Technical Bulletin

RE: Taktis EN13 firmware wireless network legacy mode

Network Site Details

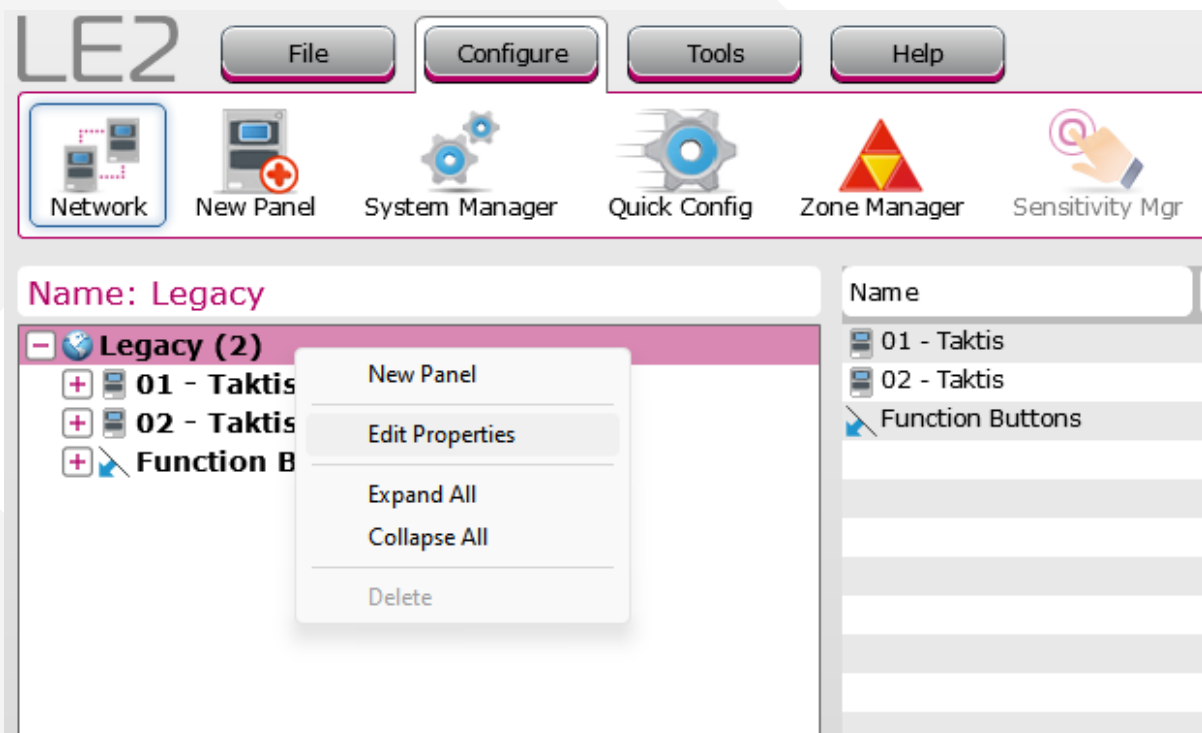
Changes have been introduced in the EN13 Taktis firmware that affect the EMS wireless Taktis panel networks using the EMS Taktis Radio Network Communicator. To allow the EMS wireless network to work with the EN13 Taktis firmware Kentec have added a Legacy wireless mode to the LE2 configuration options. This legacy mode does not affect the general operation of the Taktis network but does allow the wireless network to function as it did on previous versions of Taktis firmware.

Legacy Wireless Networking: WARNING: Selection required for Radio Network Communicator (RNC) Firm ware revision 3.02 or less.

This mode can only be enabled using LE2 software-

Once the site configuration has been downloaded from all network panels using LE2, Select Edit Properties by right clicking the site name-

Tick both Legacy wireless networking options and click save-

Upload the configuration to all Network panels.
